FED. ROAD DIST. NO.	STATE	FED. AID PROJ. NO.	FISCAL YEAR	SHEET NO.	TOTAL SHEETS
HAWAII	HAW.	NH-072-1 (51)	2007	C.O. ADD. 54	106

STATE OF HAWAII
DEPARTMENT OF TRANSPORTATION
HIGHWAYS DIVISION
**TYPICAL DUCT SECTION
BACKFILL DETAILS**
Kalanianaʻole Highway Improvements
Retaining Wall at Makapuu, Oahu
Federal Aid Project No. NH-072-1 (51)
SCALE: AS NOTED
DATE: APR. 2007
SHEET No. E-14 OF 18 SHEETS

Kalaniana'ole Highway Improvements
Retaining Wall at Makapuu, Oahu
Federal Aid Project No. NH-072-1 (51)

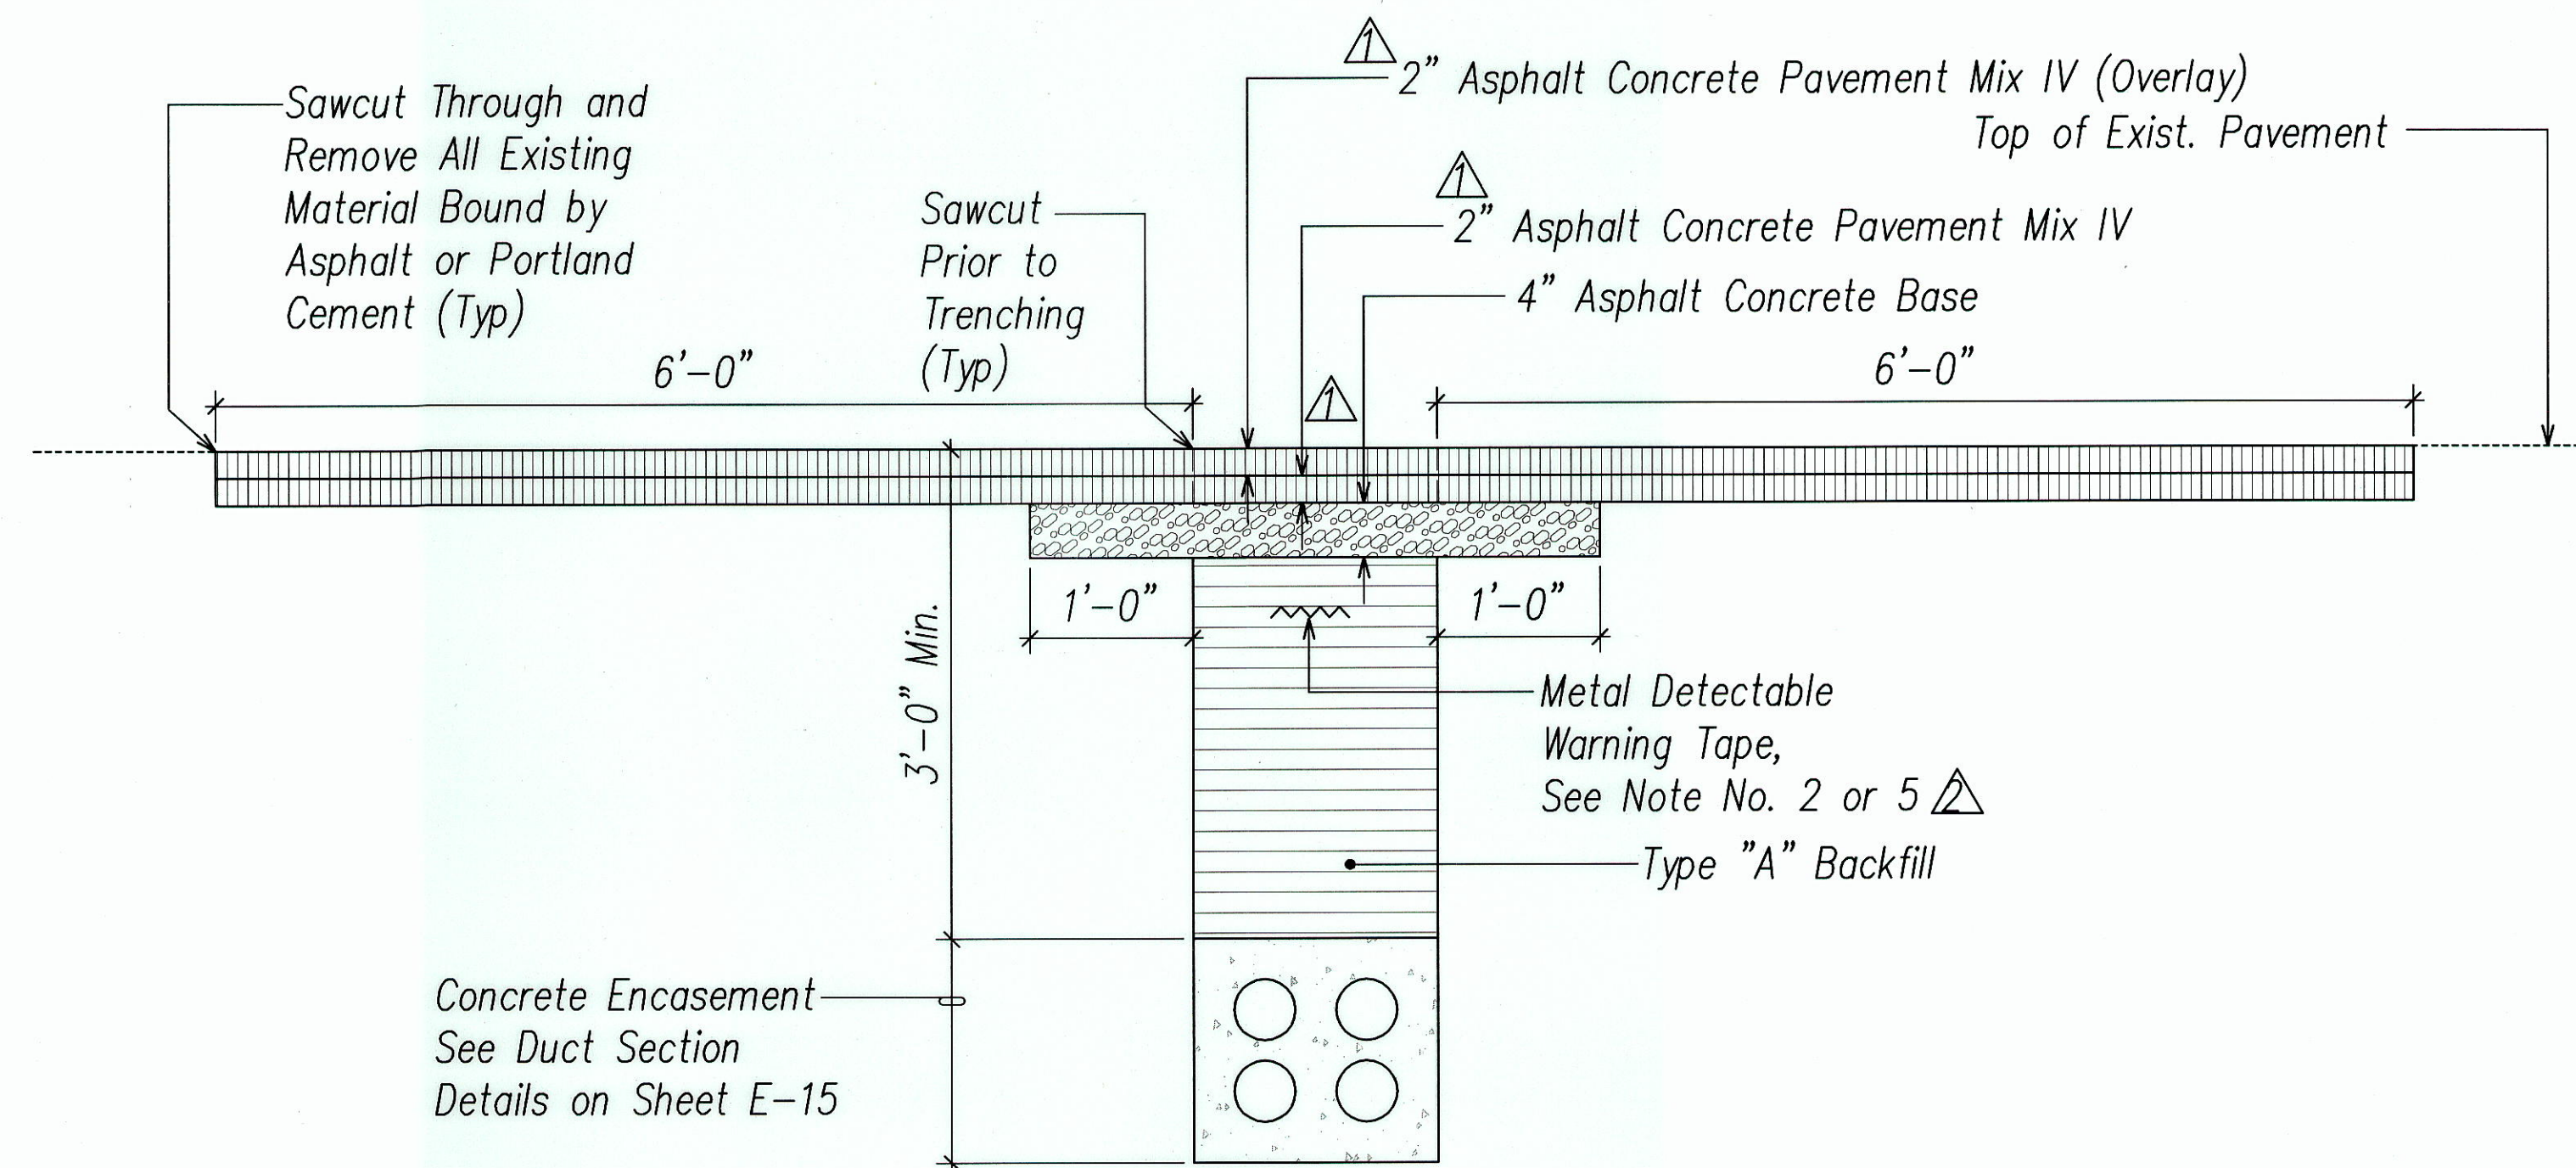
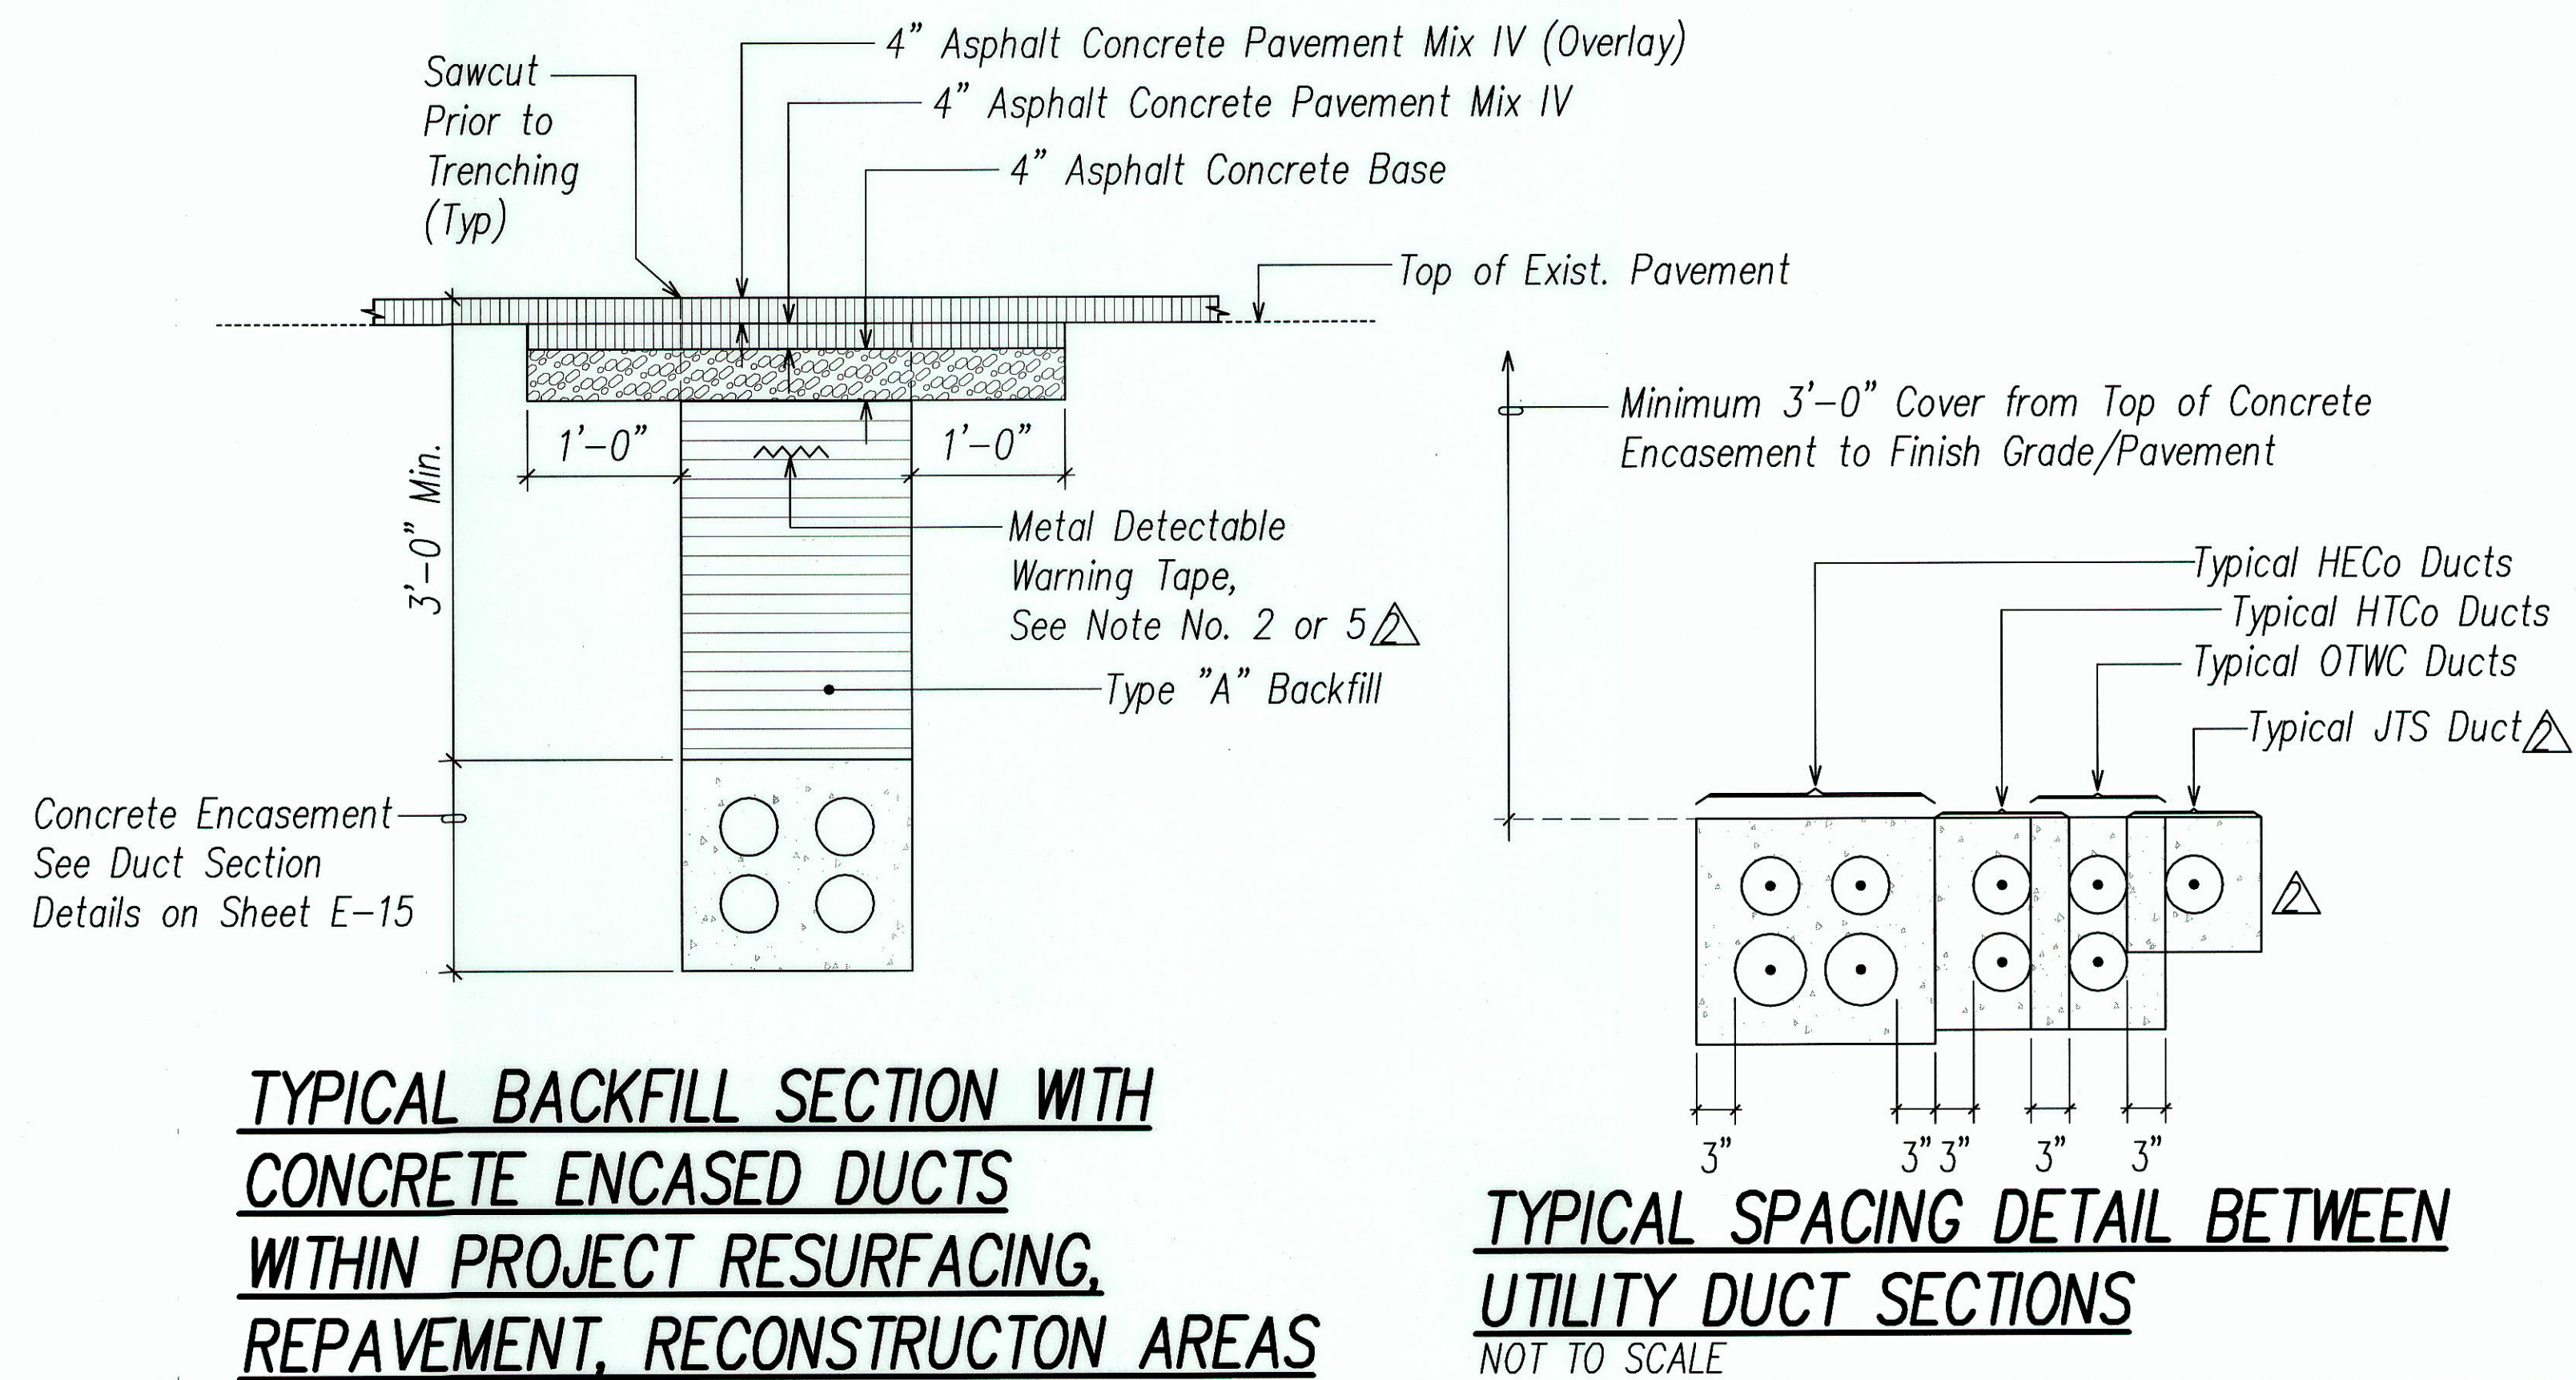
02/09/2010	Added JTS Duct Requirements
03/09/09	Revised Pavement Thickness
DATE	REVISION

5. Detectable Warning Tape For JTS Ductline shall be as follows:

- a. Warning tape shall be polyethylene (PA) plastic tape, a minimum of 6 inches, IAW APWA Uniform Color Code, and imprinted with the words "Warning - Telecommunication Cable Below" at not more than 48 inch intervals. Minimum thickness of the tape must be 0.004 inch. Tape must have a minimum strength of 1750 pounds per square inch (PSI) lengthwise and 1500 PSI. Tape must be manufactured with integral wires, foil backing, or other means of enabling detection by a metal detector when tape is buried up to 3 feet deep. The materials in the warning tape must be chemically inert and will not degrade when exposed to acids, alkalis, and other destructive substances found in soil.

- b. Detection wire must be insulated, single-strand, solid copper with a minimum of 12 AWG coated with a minimum of 30 mm PE Jacket designed specifically for buried use.

- c. Detectable warning tape must be installed 12 inches to 18 inches above all new non metallic conduit formations and must not exceed the manufacturer's recommended depth below grade. Tape must be placed at a depth of no less than 12 inches below surface grade.

- d. Permanent tracer wire must be installed in all new duct banks. One tracer wire must be installed per duct bank. The tracer wire must be placed centrally as possible in the top conduit formation. Splices in the tracer wire must be connected by means of a compression type connector to ensure continuity. Wire nuts must not be used. After installation, tracer wire should be tested to verify continuity of the tracer wire system and a report indicating continuity should be submitted to the permitting authority as part of the As-Built construction records.
